ZANCOR HOMES COLOUR CHART

SCHEDULE "E-1"

PURCHASER EXTRAS

Lot / Unit
74House Type
Ambian (42-7) Elev A Elev

GROUND FLOOR

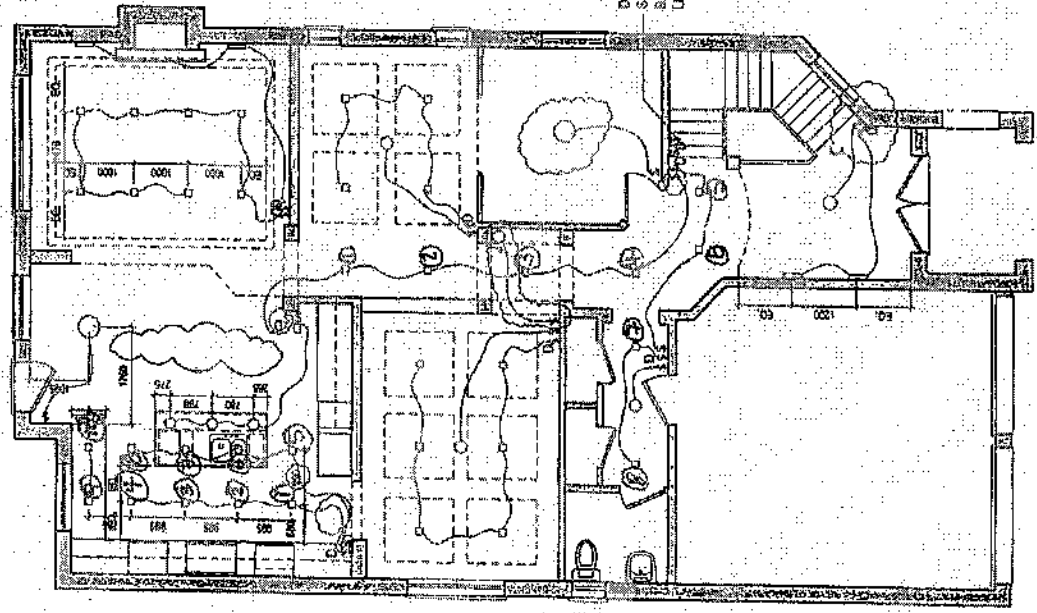
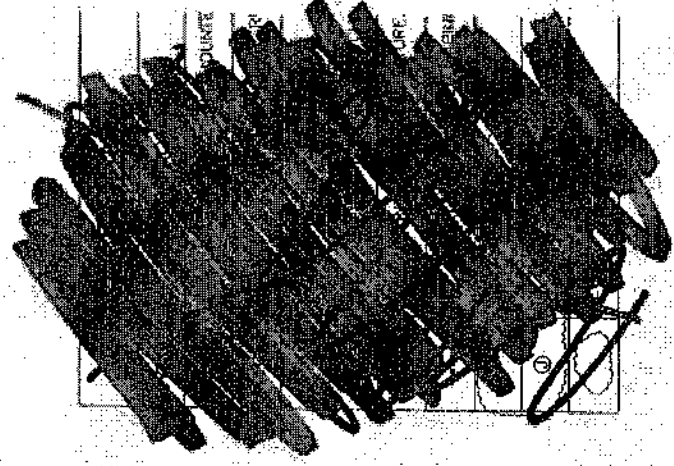
31). BREAKFAST ROOM: ELECTRICAL MOVE STD CEILING LIGHT 1095 FROM WINDOW WALL AND 1760 FROM WALL BEHIND DOOR. SEE PLAN FOR APPROX. LOCATION	
32). GREAT ROOM: ELECTRICAL: INSTALL (8) LED module 4 inch line voltage DMF Value Series (3000K Calvin Colour) with the square trim in silver. DIMMABLE LED. *DELETE STD LIGHT *DISCOUNT GIVEN FOR HAVING MORE THAN 15 POTLIGHTS ON MAIN FLOOR *Dimmer switch included in price (1)

35). MAIN HALL: ELECTRICAL: INSTALL (8) LED module 4 inch line voltage DMF Value Series (3000K Calvin Colour) with the square trim in silver. All light to be installed on dimmable switch POTLIGHTS 1-4 TO BE ON SAME SWITCH. See plan for location POTLIGHTS 5-6 TO BE ON SAME SWITCH. SEE PLAN FOR LOCATION POTLIGHTS 7-8 TO BE ON SAME SWITCH. SEE PLAN FOR LOCATION **DELETE STD LIGHT IN MAIN HALLWAY. DO NOT DELETE STD LIGHT IN FRONT OF CLOSET DOORS OR FOYER *DISCOUNT GIVEN FOR HAVING MORE THAN 15 POTLIGHTS ON MAIN FLOOR

46). FOYER: ELECTRICAL: INSTALL (2) WALL SCONCES ON THE WALL THAT IS SHARED WITH THE GARAGE. INSTALL 1200 APART FROM EACHOTHER BUT EQUALLY DISTRIBUTED ON THAT WALL. SEE PLAN FOR FURTHER DETAILS

□ - LED POUTLIGHT SQ TRIM
D - Dimmable Switch

+Client's Sketch
SECOND FLOOR REFLECTED CEILING PLAN
SCALE 1/8" = 1'-0"

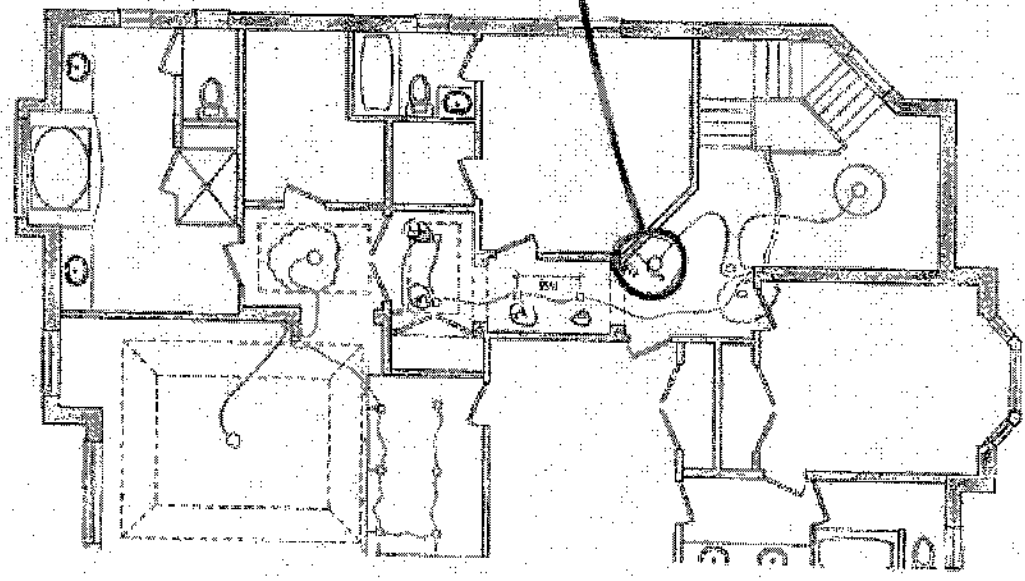
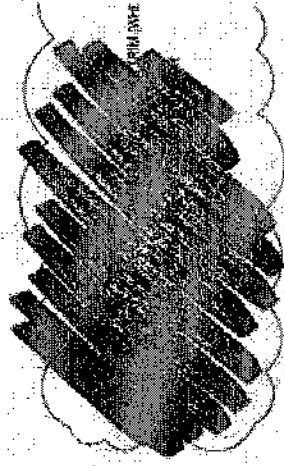
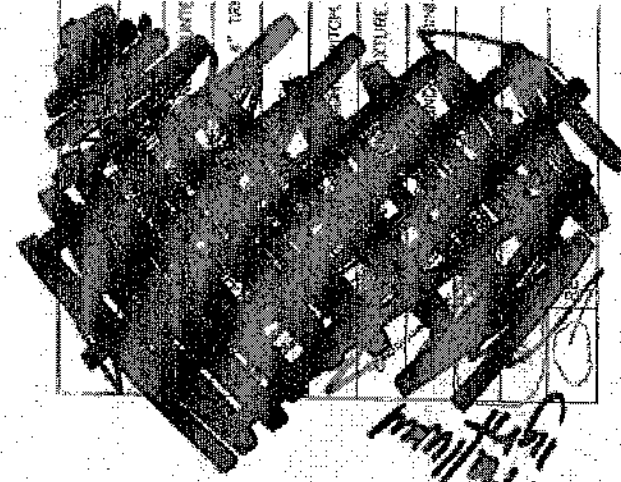
36). UPPER HALLWAY: ELECTRICAL: Install (4) LED module 4 inch line voltage DMF Value Series (3000K Calvin Colour) with the square trim in white. Dimmable LED *Install (2) in front of bedroom and (2) in front of master bedroom *Dimmable Switch included in price TO BE ON SAME SWITCH. SEE PLAN FOR LOCATION *DISCOUNT GIVEN FOR HAVING MORE THAN 15 POTLIGHTS

37). MAIN UPPER HALLWAY: ELECTRICAL: INSTALL STD main hall light 415 from corner of wall. Install on dimmable switch See plan for location	
38). MASTER ENSUITE: ELECTRICAL: INSTALL (6) LED module 4 inch line voltage DMF Value Series (3000K Calvin Colour) with the square trim in white. Dimmable LED TO BE ON SAME SWITCH. SEE PLAN FOR LOCATION *DISCOUNT GIVEN FOR HAVING POTLIGHTS ON 2nd FLOOR *Dimmer included in price

Electrical
Panel
Request

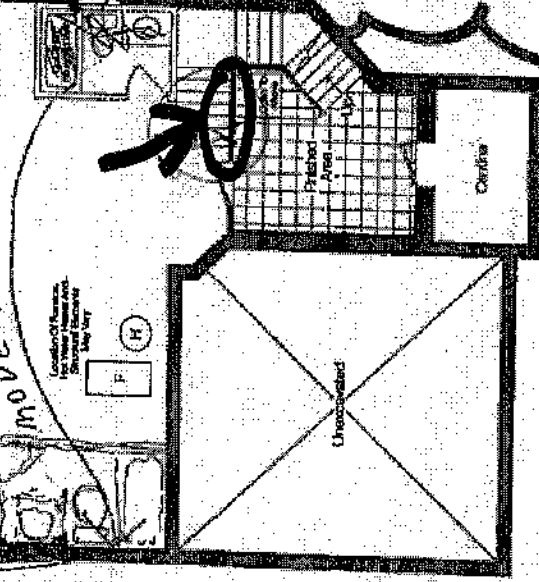
52). Electrical: Client requesting to install panel as per sketch *Client understands this is only a request and may not be installed in that location due to code

① SAME WINDOWS
SAMS
MOVE
PS

⑤ DISPOSE
JT
MA
PS
Unfinished Basement

⑥ MOVE R.I. 3 pc

⑧ MOVE
TUB &
LAUNDRY
CONNECTORS
D.D.W.
